LINCOLN-ELIOT ELEMENTARY SCHOOL

DRC & SBC MEETING

NEWTON, MA
15 FEBRUARY 2023

SUMMARY OF 60% DESIGN DEVELOPMENT COMMENTS AND RESPONSES

FIRST FLOOR 1/16" = 1'-0"

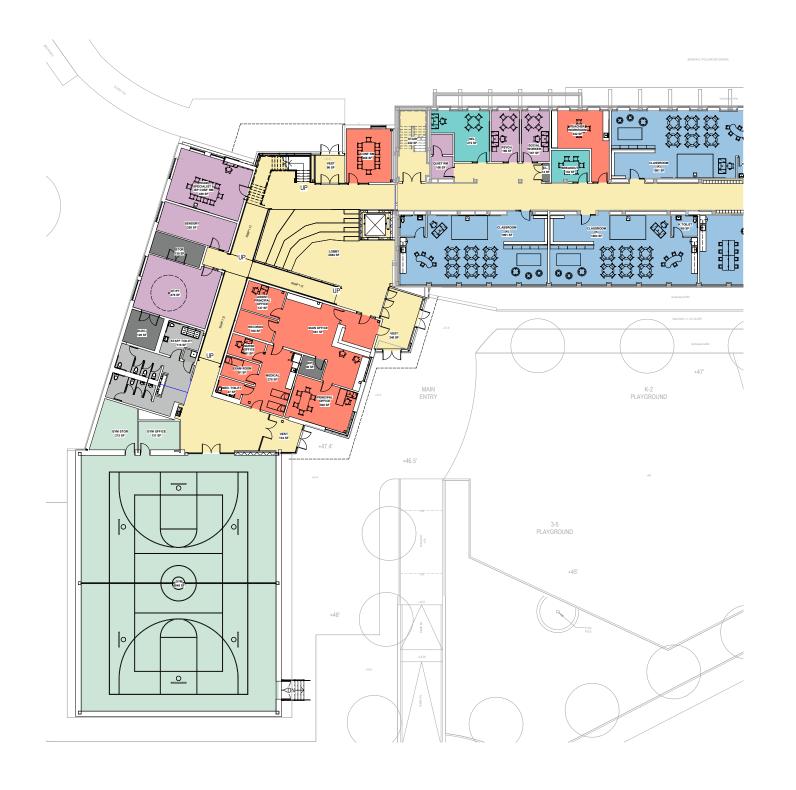
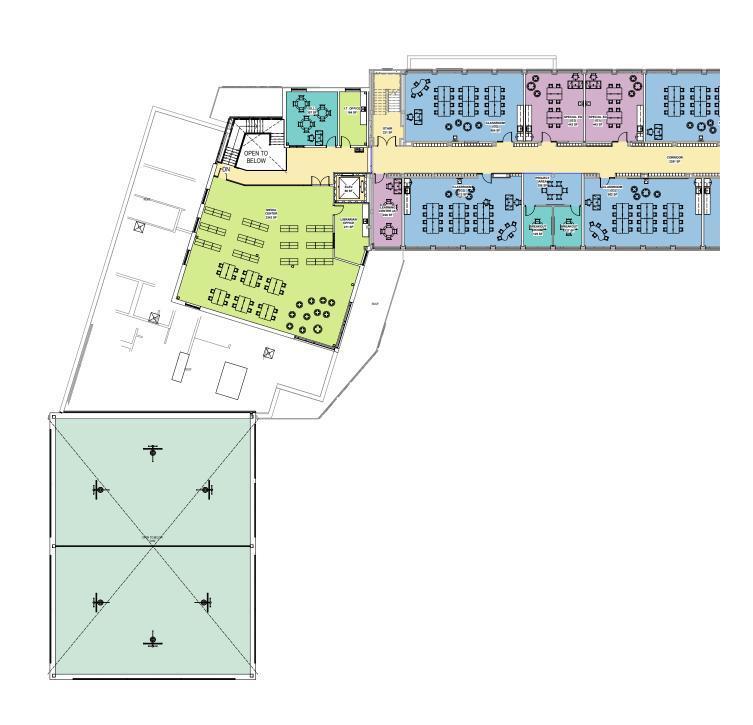
- Entry should be more welcoming
- Long travel from entrance to classrooms
- Relocate gym restrooms so they are not at the front of the building
- Reposition the main office so that the main entrance occurs after the front office
- Better sight lines to the main entrance
- Concerned interior main corridor lacks daylight and views

REVISED BUILDING ADDITION @ 1/11 DRC MEETING

SITE PLAN - 1" = 50'-0"

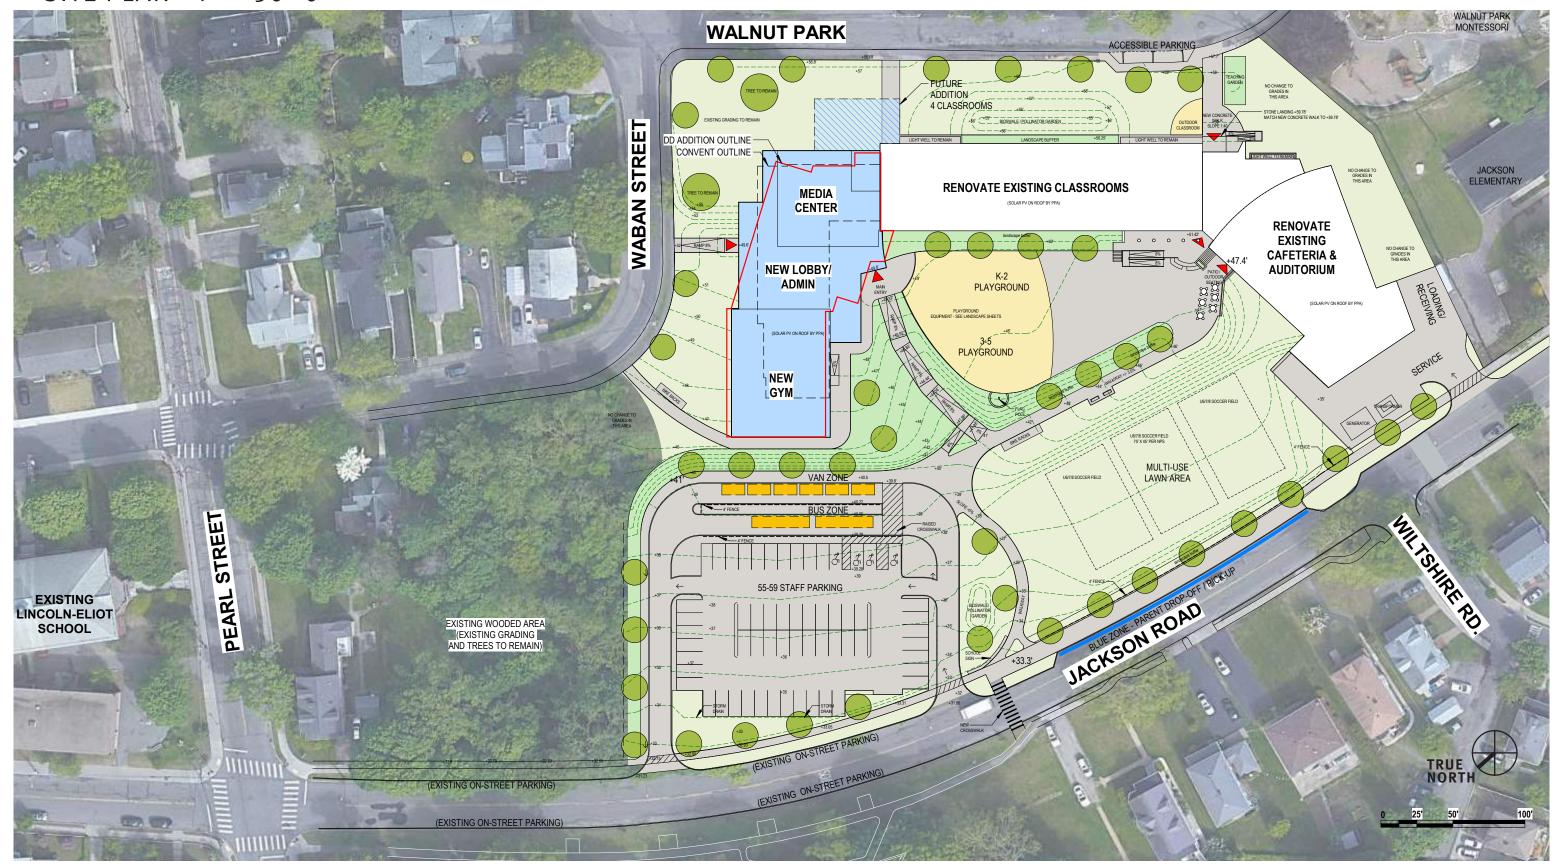
- Revised site plan will address some of the comments on the northside of the gym.
- No new landscaping work planned on the existing steep slope, south side of the Auditorium (Montessori School)
- Provisions are made for all hazmat materials.
- It is likely the existing fence between urban forest and school will need to be replaced.
- Sidewalks closures during construction will be determined by the GC and should only be required to maintain
- Project North will be adjusted so that it relative to the True North.
- Bike rack alternatives will be studied.

PROPOSED REVISION TO SITE PLAN
